Subject: 407 Mesilla St SE

Based upon the information provided in your submittal received 11/3/16, the above referenced Grading and Drainage plan dated 11/2/16 cannot be approved for Grading Permit or Building Permit until the following comments are addressed:

OVERFLOW WEIR DETAIL

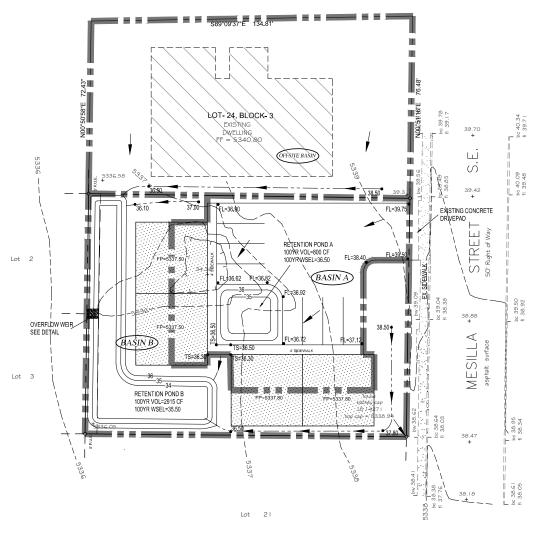
- Raise the weir by 4", enlarge the weir by 4' per our conversation on 11/16/16.
- Provide a detail of the swale.
- Provide a spot elevation on the sidewalk where the overflow from pond A to pond B is located.
- Provide a statement concerning any future fence must show an opening where the weir and the swale overflow.
